MPO RESOLUTION #2023-05
A RESOLUTION OF THE COLLIER METROPOLITAN
PLANNING ORGANIZATION APPROVING AN
AMENDMENT TO THE FY 2022/23- 2026/27
TRANSPORTATION IMPROVEMENT PROGRAM (TIP)

EXHIBIT to MPO Resolution #2023-05
TIP Amendment for Approval by MPO Board on June 9, 2023 for
FY 2022/23 through FY 2026/27 TIP

452242-1 SWRS - STATEWIDE RUMBLE STRIPS (ON-SYSTEM SOUTH)

RE: Request for TIP Amendment to the Collier Metropolitan Planning Organization's FY2022/23 – FY 2026/27 Transportation Improvement Program (TIP).

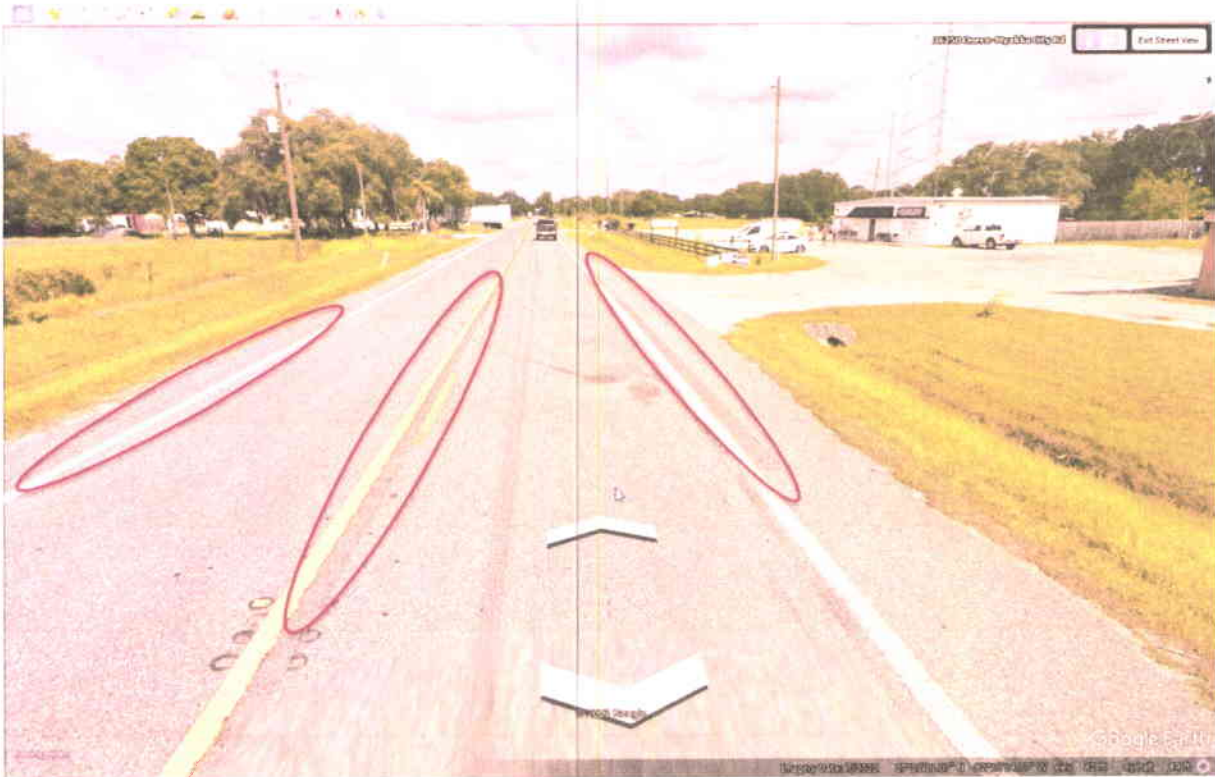
b.) Which roads in our district are included?

The projects we have will install the countermeasure on all eligible state roadways that do not already have a project in the work program that would add the countermeasure.
